# **Final Monitoring Report/Closeout Report**

Pee Dee Stream Restoration Project  
NCDMS Contract No.: 004644  
NCDMS Project No.: 95350  
USACE Action ID: SAW-2012-01077  
DWR #: 13-1140

RE: Pee Dee Stream Restoration Site: MY7 Monitoring Report (NCDMS ID 95350)

Listed below are comments provided by DMS on November 22, 2021 regarding the Pee Dee Stream Restoration Site: Year 7 Monitoring Report and RES' responses.

**Figure 2**  
**Pee Dee Stream**  
**Restoration Project**  
**MY7 2021**  
**Current Conditions**  
**Plan View**

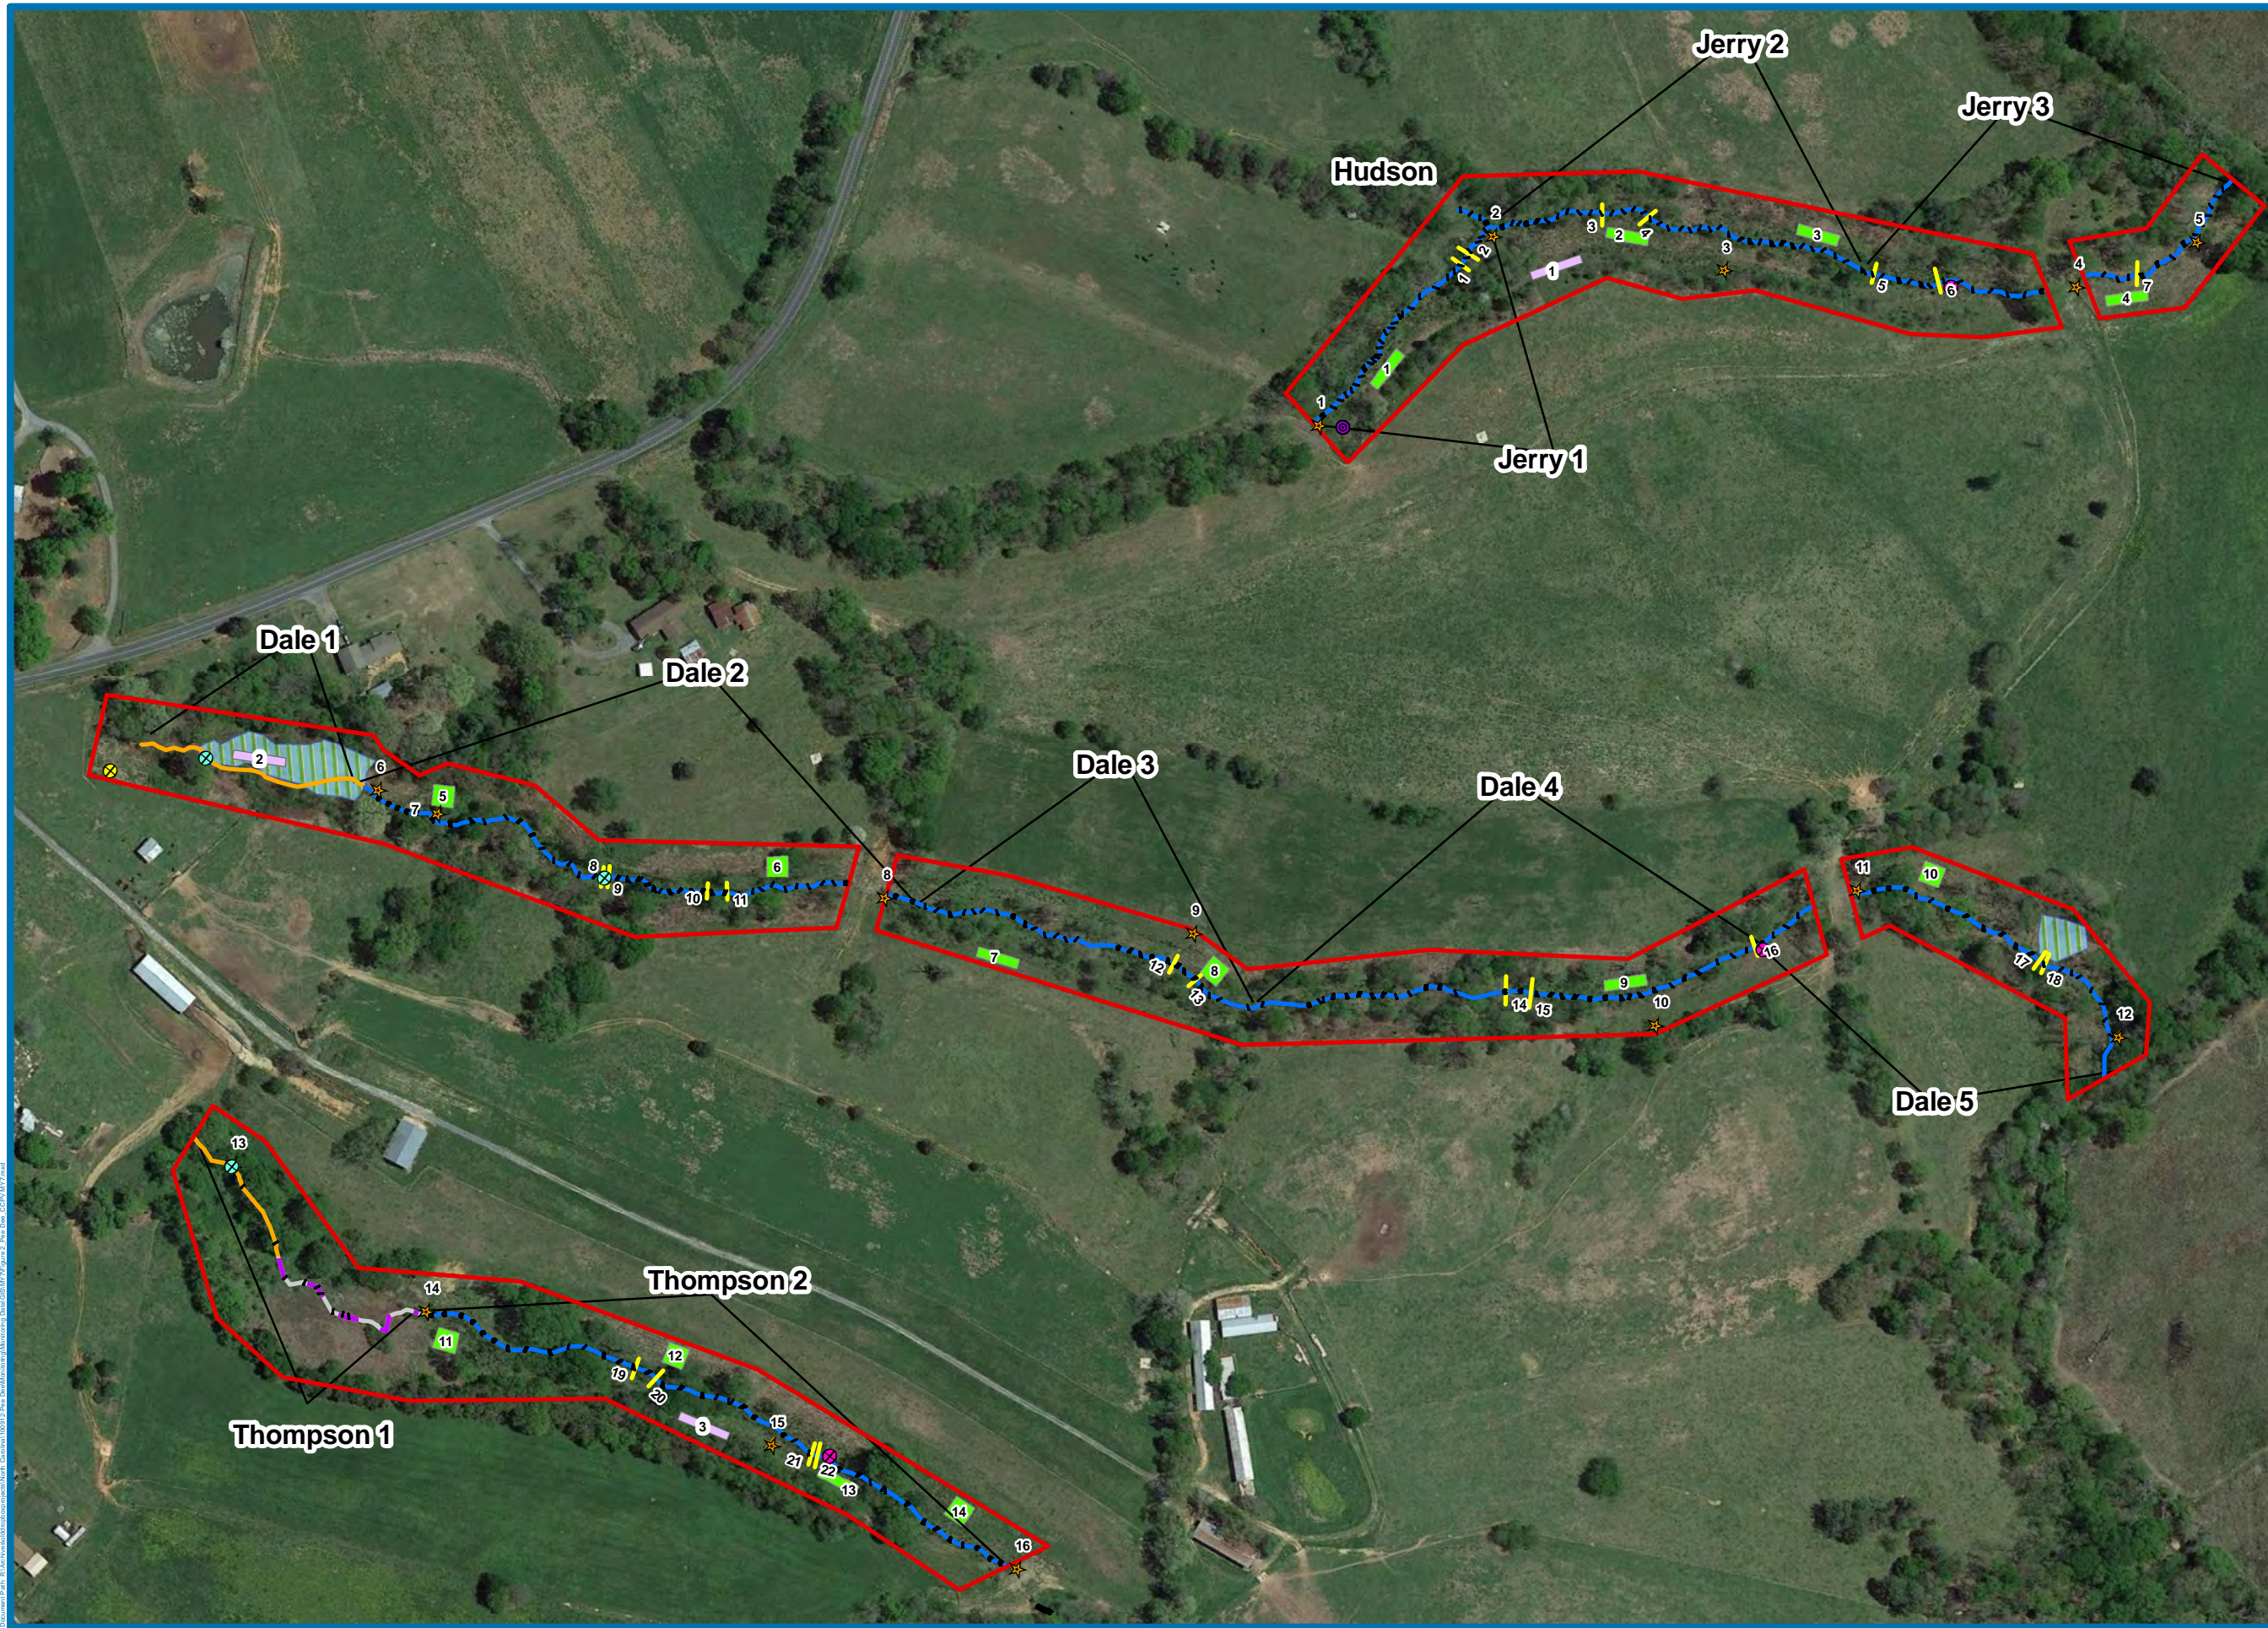
- Please submit features depicting the existing wetlands shown in the CCPV.  
Done.
- Please include a feature that characterizes the 300 ft of aggradation throughout Thompson Branch and display this feature in the CCPV.  
Done.
